**CSELR Project State Significant Infrastructure Approval (SSI-6042)
Planning Modification No. 1**

Thank you for the opportunity to comment on the proposed modifications to the CSELR project. The attached submission has been prepared based on a review of the Modification Report (referred to as *the Report* in this submission) dated December 2014.

Moore Park stop

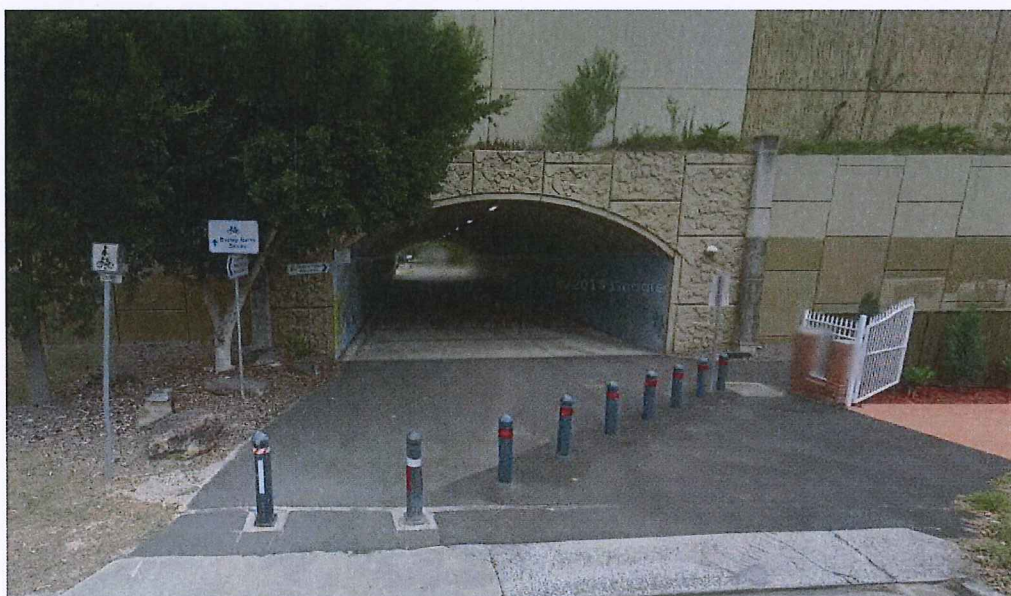
Although not within Randwick City Council area, the proposed modifications to the Moore Park Stop have implications for Anzac Parade, which is the key northern gateway to Randwick City.
